V8 XJ Series/XK

SERVICE

TECHNICAL BULLETIN

Steering Rack Knocking Or Rattling – Revised Lower Steering Column/Rack Return Line – Repair Procedure

ILLUSTRATION 1

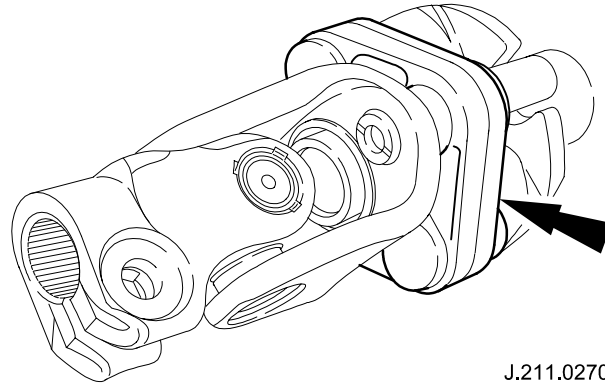
Note: The modified lower steering column has a rubber coupling (Illustration 1). If the modified lower column is present, **continue with PAS line installation only.**

On vehicles prior to VIN A11051 (XK Series) and VIN F20645 (V8 XJ Series), check to see if a modified lower steering column (modified lower steering column has a rubber coupling) has been retrofitted, if not, install a modified lower steering column and new steering rack return line.

On vehicles after VIN A11051 (XK Series) and VIN F20645 (V8 XJ Series), or if a modified lower column has been retrofitted, install new steering rack return line only.

ILLUSTRATION 2

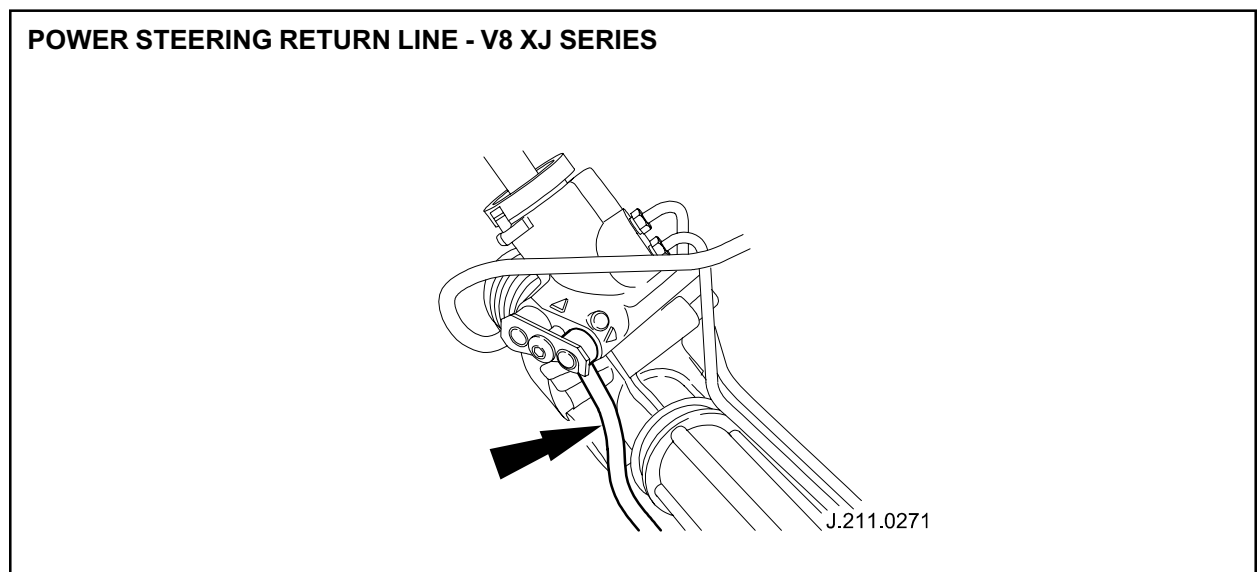
- Install PAS return line (see Workshop Manual, JTIS CD-ROM, section: 211-02, (SRO 57.15.30 for 1997-2000 MY vehicles).

ILLUSTRATION 3

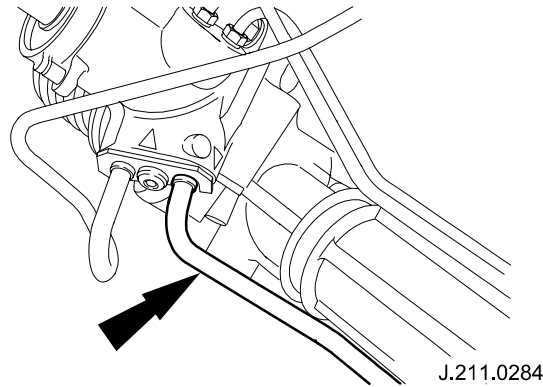
POWER STEERING RETURN LINE - XK
